Official Transcript of Proceedings
NUCLEAR REGULATORY COMMISSION

Title: Advisory Committee on Reactor Safeguards
US-APWR Subcommittee Meeting

Date: Friday, May 27, 2011

MEETING OF THE US-APWR SUBCOMMITTEE

5.3.2 RV Pressure-Temperature Limits

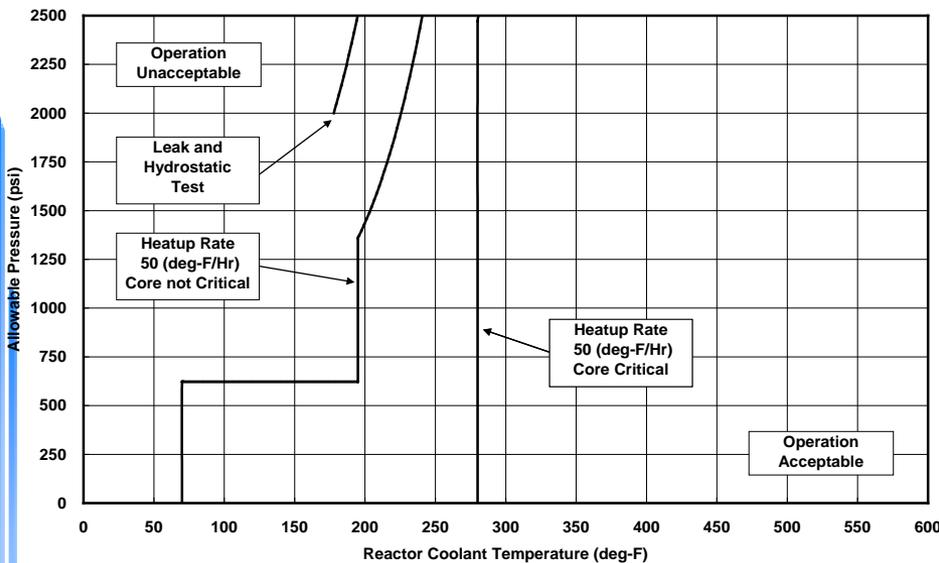
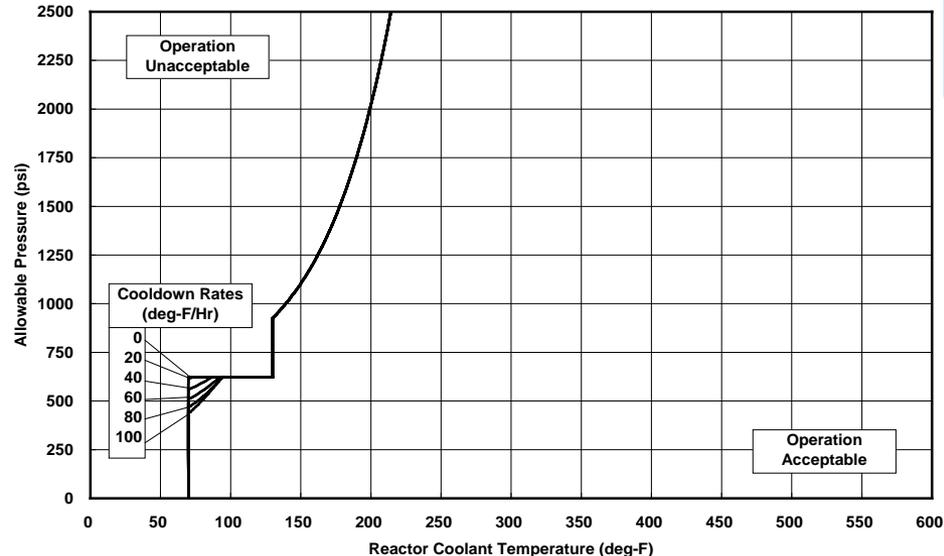
14 In this case, there are let's see two open
15 items. The first one, let me just read it. Generic
16 P-T Limit Report with bounding P-T limit curves based
17 on bounding material properties and projected fluence,
18 following the guidelines of GL96-03. This was a RAI
19 question but the answer was not factored into the SER.
20 But it was answered, the second bullet there says MHI
21 submitted this P-T report and it just hasn't been
22 incorporated at this time. That's all. The next
23 item, the P-T limit for the reactor vessel are based
24 on evaluation of the reactor vessel beltline and
25 closure flange reasons. Explain how this relates to

1 the nozzles and the remainder of the RV. The response
2 is that the RV fracture mechanics evaluation addresses
3 limits for the entire RV including nozzles is in
4 process. The fracture mechanics analysis comes after
5 the stress analysis and there's a lot of, the stress
6 analysis is not yet complete of all of these parts.
7 But this is also an in process and I think consistent
8 with. The beltline region was presented first because
9 it was generally most interesting information to start
10 with. Let's go to the next slide.

5.4.1 Reactor Coolant Pumps

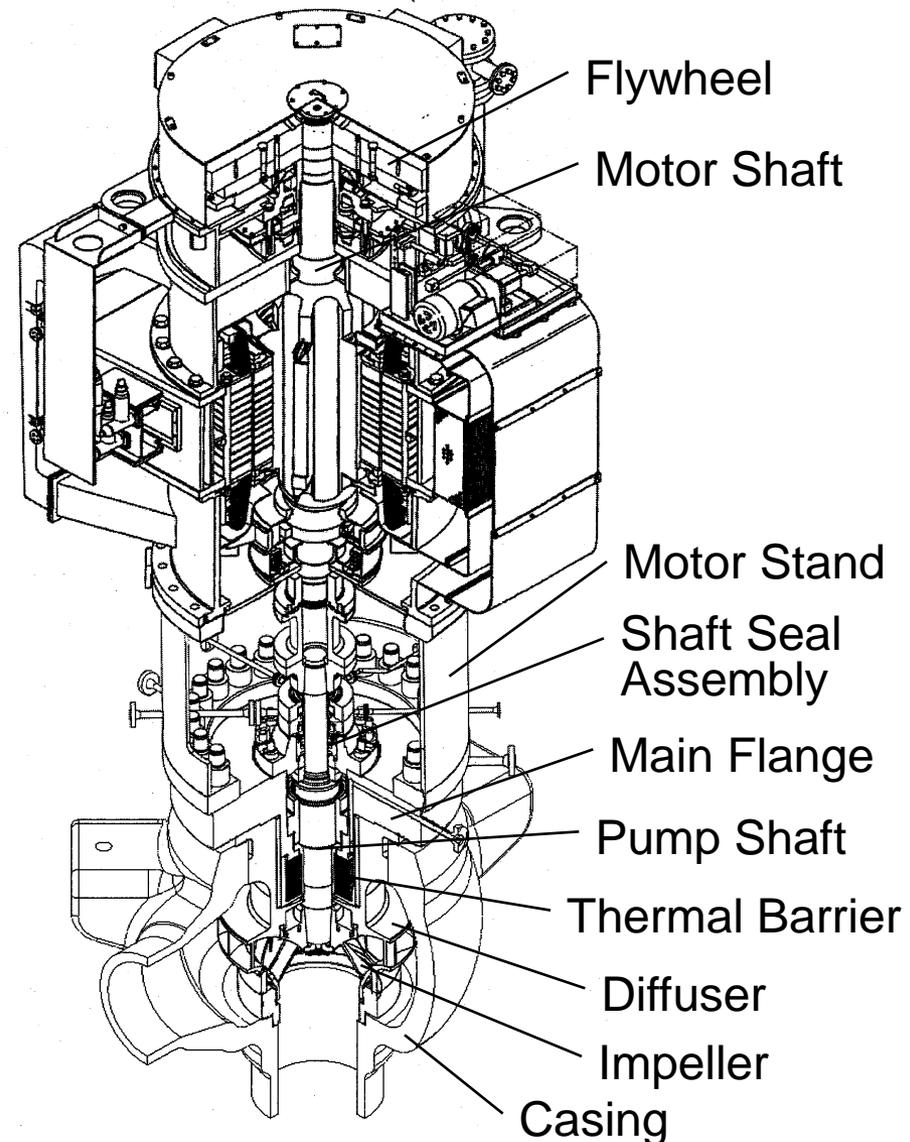
11 CHAIRMAN STETKAR: I had a question also
12 on the flywheel integrity and this may be obviated by
13 the probabilistic fracture mechanics analysis that was
14 done. The nominal speed of the reactor coolant pump
15 is 1200 rpm and for an overspeed during LOCA analyses,
16 you take credit for the leak before break analysis, at
17 least in the deterministic analysis to justify that
18 the limiting overspeed would be 1500 rpm, 25 percent
19 larger. I didn't look the probabilistic fracture
20 mechanics. Do they look at ranges of overspeed
21 greater than 1500 rpm in that analysis Bill?

22 CHAIRMAN STETKAR: I'm not saying I'm
23 concerned about this. I'm just raising a question
24 about how far did the analysis look beyond that
25 nominal 1500 rpm overspeed limit, which is essentially

12 MR. WILSON: There are two open items
13 related on the pump. The first one, there were two
14 RAI questions that were wrapped up in one open item,
15 open item number two. The staff requested additional
16 information about a critical flaw size associated with
17 1500 rpm design speed. Let me comment. They asked
18 this because the information provided by MHI was that
19 at much higher speeds. They basically had numbers
20 that went to basically as a function of flaw size and
21 run into the, you know, how big, the numbers were very
22 big, much bigger than 1500 rpm.

1 in the deterministic analysis a fixed limit. I
2 recognize you've submitted the probabilistic fraction
3 mechanics and the staff with the exception of that one
4 open item has accepted the probabilistic fraction
5 mechanics as a basis for the inspection interval. So
6 therefore the question then evolves into what's the
7 justification for the probability distribution that's
8 assigned around that overspeed, that 1500 rpm
9 overspeed and has that adequately captured the
10 probability of perhaps higher overspeeds. So, as far
11 as my deterministic question, I think I'm satisfied.
12 Thank you.

5.4.11 Pressurizer Relief Tank

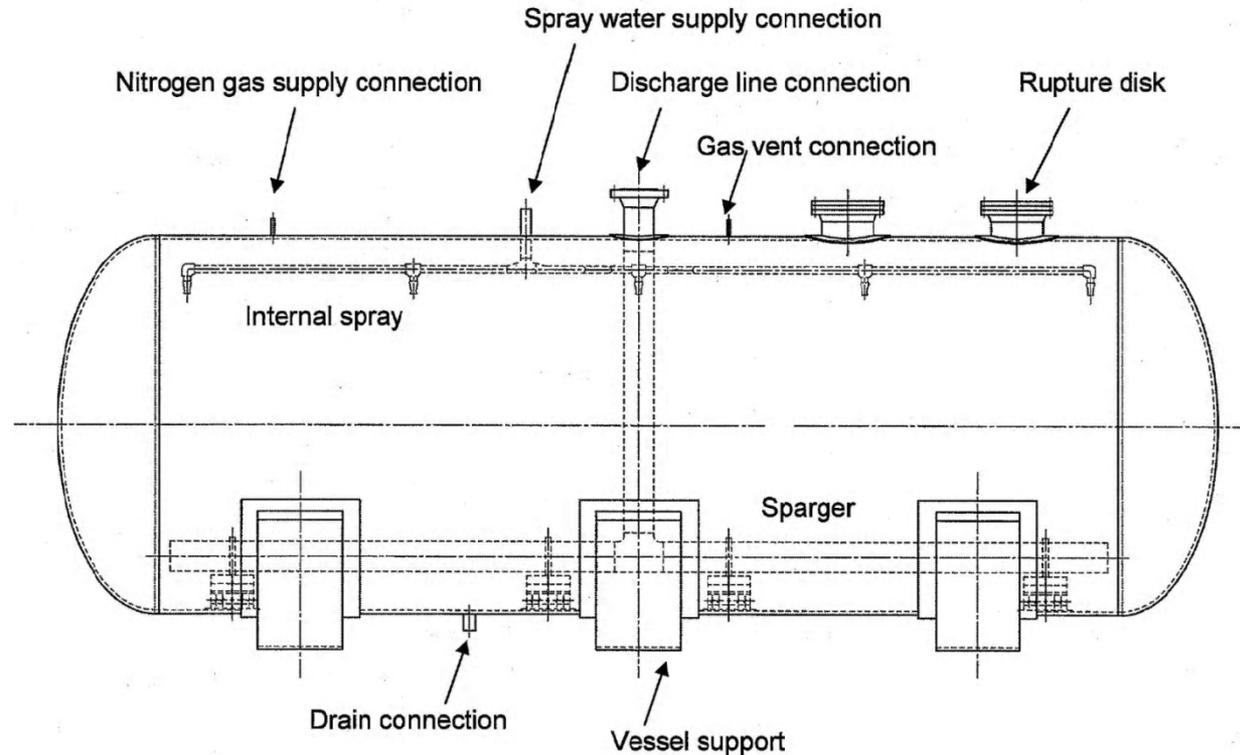
14 There are two open, three open items on
15 this that relate to this section. The first one is
16 for item one. Provide information, additional
17 information about the PRT and the rupture disk.
18 Basically the question is rupture pressure versus the
19 PRT design pressure. Then the next is ruptured disk
20 flow capacity versus the combined capacity of the
21 pressurizer safety valves. And the third has to do
22 with the external pressure design or design pressure
23 for the PRT. These are just, I'm not sure of the
24 history but these questions came up at a time after
25 the SER was, I mean it didn't get answered before

1 that. We're working on a response but basically you
2 can see the information was readily available. The
3 rupture disk design pressure is 190 psi plus zero
4 minus five percent and the design pressure is 200
5 psig. So, the pressurizer safety valve maximum flow
6 which is in Chapter 5 is 432,000 pounds per hour and
7 there are four of them. And the rupture disk are
8 sized to a flow greater than this value. The PRT is
9 required to meet the ASME Section III rules for
10 external pressure. The delta P, design pressure is 15
11 psi. So, I anticipate this will go with, based on
12 these answers to those questions. The next open item
13 identify a reference and provide a description that
14 shows the PRT rupture disk did not pose a missile
15 threat. And the responses in preparation but the
16 rupture disks on the PRT form, they perform their
17 pressure relief function without producing a missile
18 of any type. So, I think this is one of the cases

5.4.7 Residual Heat Removal System

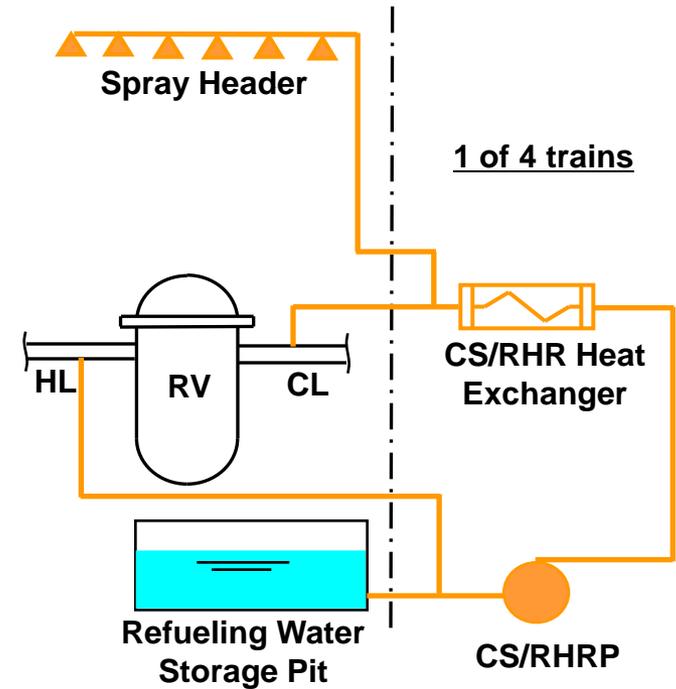
16 CHAIRMAN STETKAR: Let's stop and go back
17 because I have several questions about the RHR system.
18 The first question, I have a couple of questions for
19 just technical facts. Is the RHR system for the
20 USAPWR initiated automatically or is it only manual?

1 errors during maintenance, personnel errors during
2 testing or in some cases spurious protection signals
3 or even spurious electrical signals, we had
4 inadvertent closure of the RHR suction valves. And in
5 deed lost RHR cooling for some period of time until we
6 could determine the cause for the valve going closed
7 and get the valve reopened. There have been a number
8 of other similar type events documented at least in
9 U.S. operating history. The LTOP system does not
10 provide any over protection for heat up if the RHR
11 suction valves are closed. So the question is have
12 you considered events that cause spurious closure of
13 the RHR suction valves as part of your analysis which
14 would of course then by itself cause a heat up because
15 you've lost RHR cooling and could result in an
16 overpressure condition? Number one, have you
17 considered those events and number two, if you have
18 what type, what kind of time frames are we looking at

19 under conditions when the plant would normally be
20 water solid, which could be fairly early during a
21 shutdown period? What is the time frame before you
22 reach an overpressure condition so the operators,
23 before the operators can open those, reopen those
24 valves? Do you understand what I'm asking? I may not
25 be asking the question very well. The scenario would
